In The Matter of the Resource Management Act 1991 (“the Act”) And

In The Matter Plan Change 69 – Lincoln

## OFFICER COMMENTS OF MURRAY ENGLAND

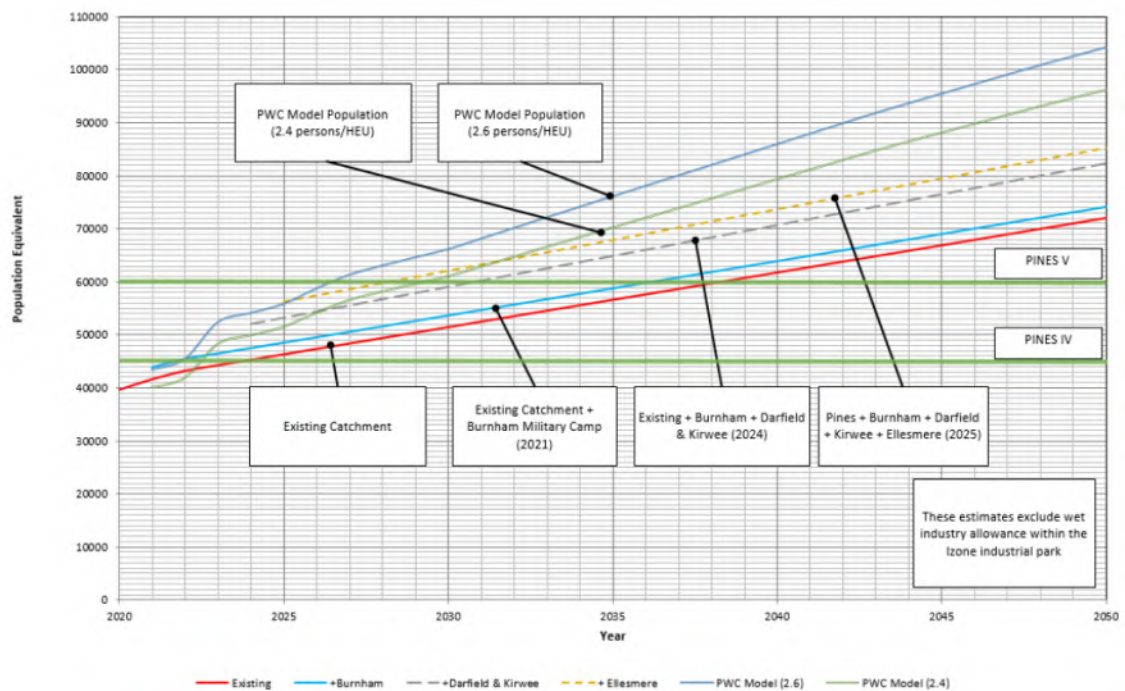
48. In my view, it is critical that this plan change application does not cause any reverse sensitivity issues which would obstruct the future consenting and operation or lead to an increase in odour or other complaints relating to the Lincoln Pond. If reverse sensitivity issues (including complaints) result in obstructing the future Lincoln Pond consenting and operation, then there will be insufficient wastewater storage capacity to provide for the growth sought to be enabled by the proposed plan change and emergency storage in the event of infrastructure failure within the ESSS network.
49. Should the plan change be approved, I consider there should be measures put in place to avoid reverse sensitivity issues arising from sensitive activities (including residential activities) establishing. I consider that one way this could be achieved is

though the imposition of a setback area, consistent with the existing rule in the Operative District Plan, within the plan change area preventing sensitive activities from establishing. This should include planted areas on the boundary of the site.

50. It is important that the sensitive activities are kept away from the Lincoln pond and therefore 150m off set must be maintained as provided for in the current District Plan for residential areas adjoining the Lincoln pond.
